# Test Fixture Delay

## (Comment #110/#111/#112/#113)

IEEE P802.3ck Task Force Interim Meeting

July, 2020

# Tfx value vs Differential TDR of MCB and HCB

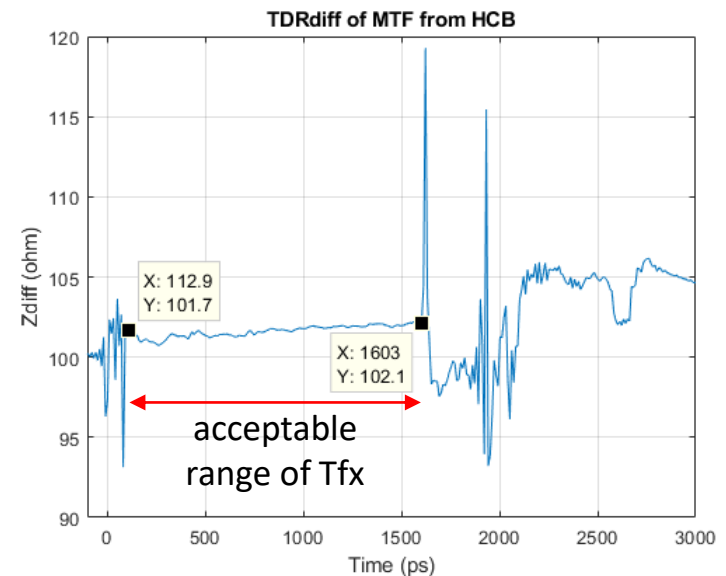
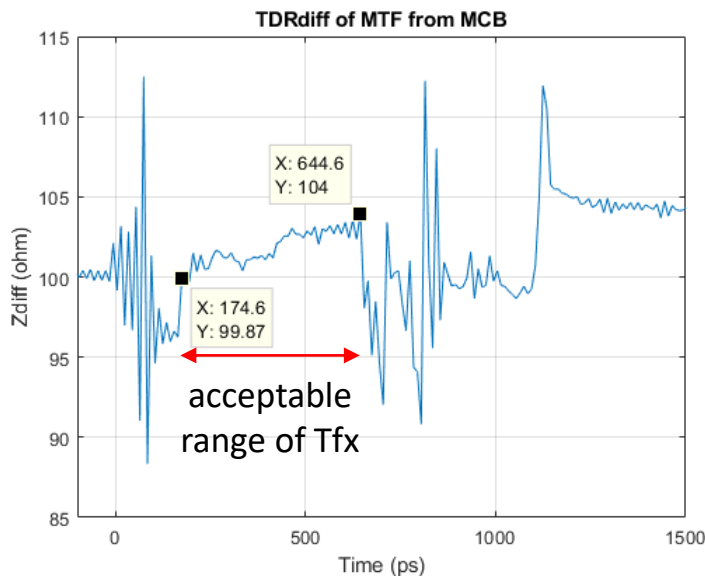
"The beginning of the host connector" is not clear.

Where is “the beginning of the host connector”?

- Below are differential TDR of OSFP Mated Test Fixture transformed from measured S-parameters contributed by Sam Kocsis (Amphenol) to Task Force (kocsis\_3ck\_02\_0719\_MTFosfp.zip).
- The optimal Tfx value may be about 640ps (MCB, left) or 1600ps (HCB, right), close to the end of flat impedance range. However, this point is difficult to define without ambiguity.
- Since **Nbx is 0 in Annex 120G and Clause 162**, optimization of Tfx is not important. Any Tfx value is acceptable between 175ps and 640ps (MCB, left) or between 113ps and 1600ps (HCB, right), because ERL will be similar for any Tfx value in this range of flat impedance.
- 200ps seems enough for various possible MCB and HCB designs** to mask the initial impedance discontinuity due to coax connector etc. A fixed Tfx value is fair and eliminates ambiguity.

Change the text “The value of Tfx is twice the delay from the measurement point TP1a to the beginning of the host connector.” to

“The value of Tfx is 0.2 ns representing twice the transmission line delay which sufficiently mitigates the test point and transmission line return loss.”
